**APPLICATION TO AMEND A
PLANNED DEVELOPMENT OR PUD
and/or
APPLICATION FOR FINAL PLAN APPROVAL
IN UNINCORPORATED AREAS ONLY
[LDC Section 34-380 or 34-1037]**

Project Name: River Hall ADD

- ☒ Amendment to a PD or PUD to allow: updates to Zoning Resolution and MCP to reflect current conditions.
☐ Final Plan Approval for: _____

COMMUNITY DEVELOPMENT
ADD 2018-00058

**COVER SHEET
AND
LOCATION MAP**

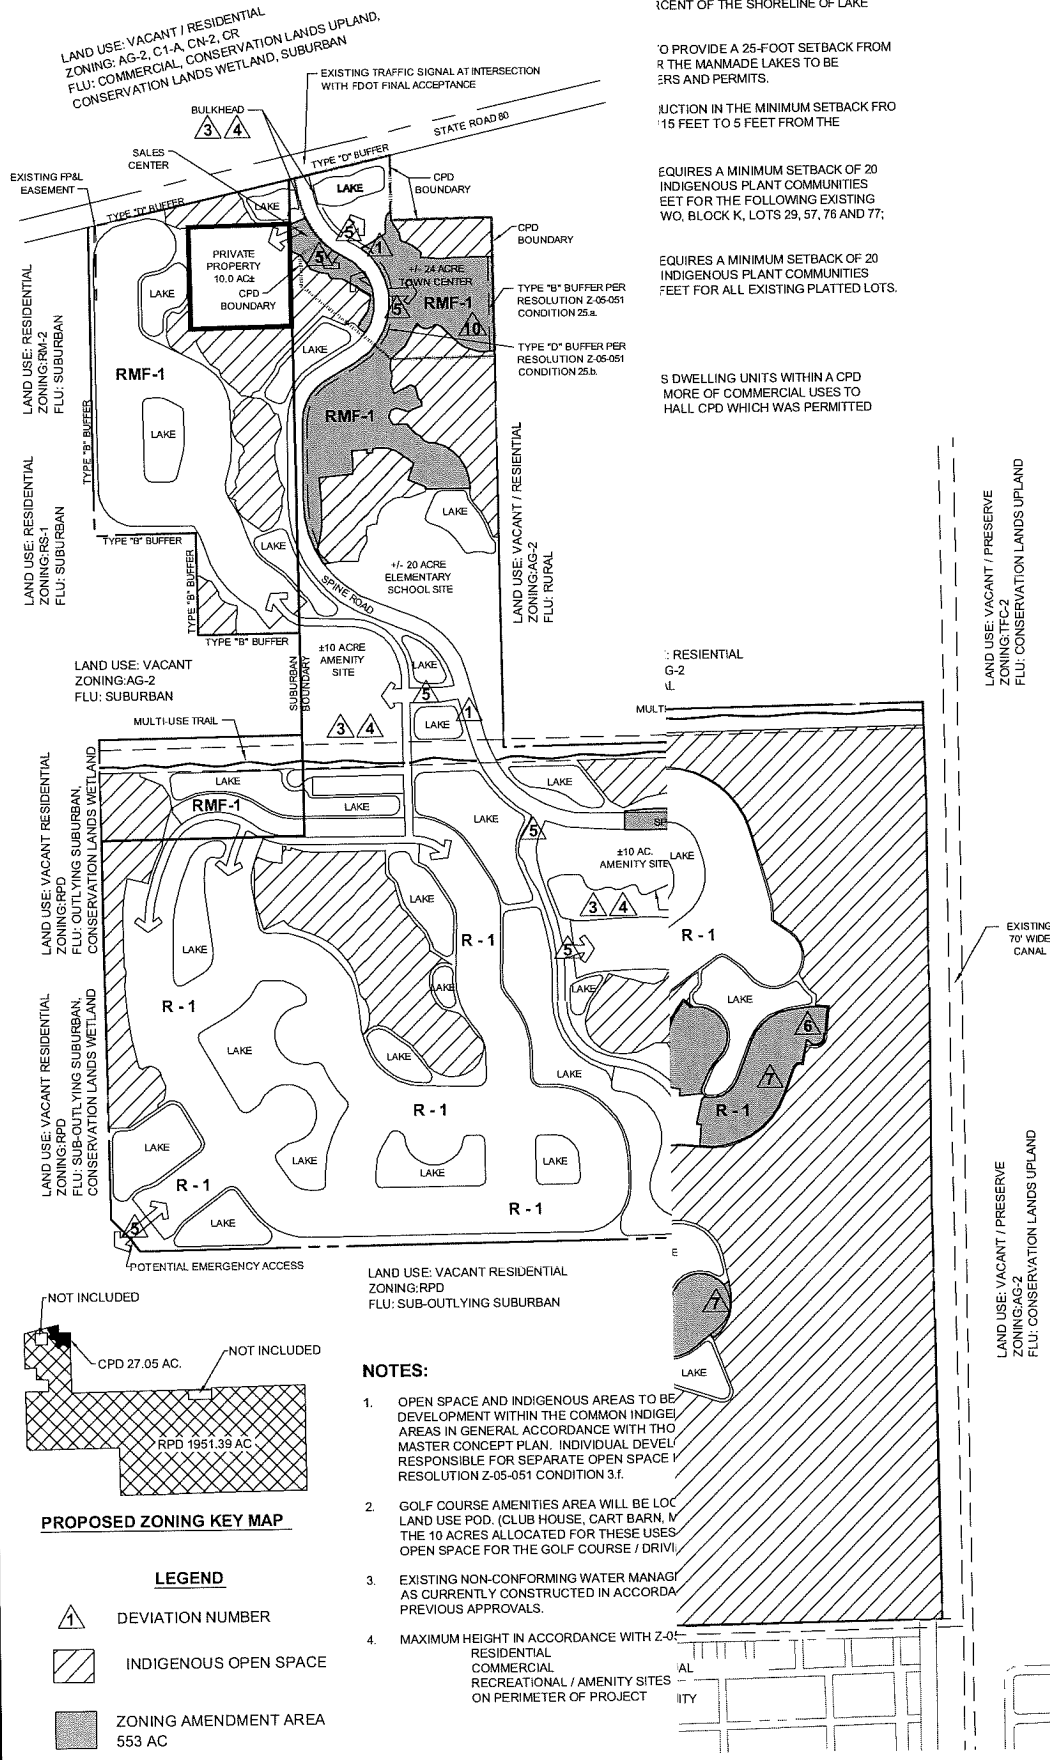
3-20-13	REVISED AMENDMENT AREA
12-17-14	REVISED AMENDMENT AREA
1-23-15	
2-15-18	TRAFFIC SIGNAL ADDED
